E4438C-16

S E R V I C E N O T E

E4438C with option 300 only

Solution/Action:**A9 Digital Demodulator board modification.**

Figure A

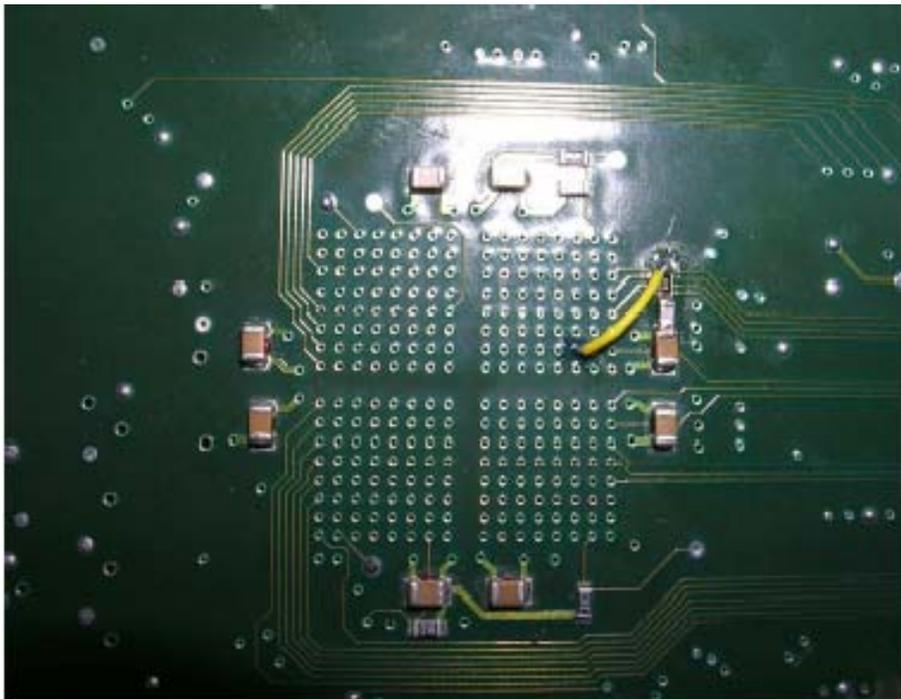
When the E4438C with option 300 is used in a Base station test system and the ESG-C 10 MHz out signal is used as a reference for another device. The internal 10 MHz signal is pulled down in amplitude and causes intermittent PDCH synchronization Lock lost errors. Other errors that maybe experienced are Error 623 or Error 522

- 1) Replace the (A9) Digital Demodulator board E4400-60510 with one that has the RC filter installed on the back side of the board. (See Figure A) A9 Board with this modification will be Version (VUF)A0101

To verify the correct version press [Utility][Instrument info] [installed board info] This will display the PC board name, part number, serial number, **Version**, bus and status.

Boards with out modification and wrong version numbers should be return to the factory.
